# Revised Chassis Grounding for the Freedom Marine Inverters

Errata

976-0122-01-01 Rev A

This Errata contains changes to the grounding section of the Freedom Marine manual: 445-0194-01-01 Revision 2.

## Chassis Grounding

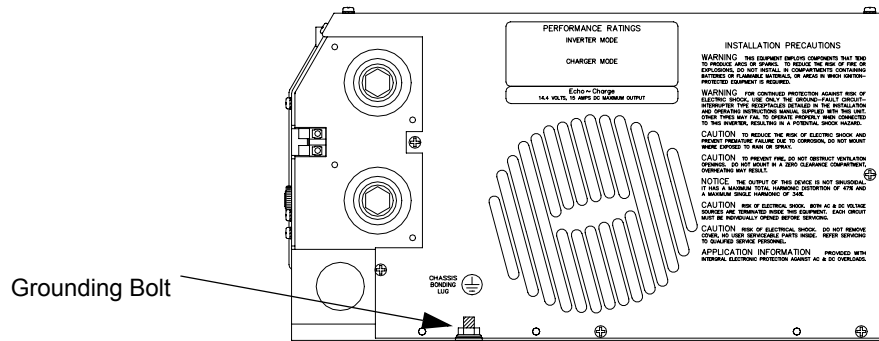
The chassis ground connection to the inverter, which is also known as the DC ground in the marine industry, has changed to improve connectivity.

The chassis ground lug on the inverter has been removed. This has been done for several reasons, but the most important reason is to improve connectivity.

There is now a 3/4 inch circular area around the bolt that is free of powder coat. The bolt, a stainless steel washer and a serrated nut will be included with the inverter, however you will need to provide a ring terminal or other ABYC-compliant lug to ground the unit.

According to ABYC, the copper lug of the cable can't be placed in direct contact with an aluminum surface, however, a stainless steel washer may be placed in between the lug and the chassis.

1. Chassis of the inverter
2. Washer
3. ABYC-compliant grounding lug
4. Serrated nut

Please torque the nut to 85 inch pounds.
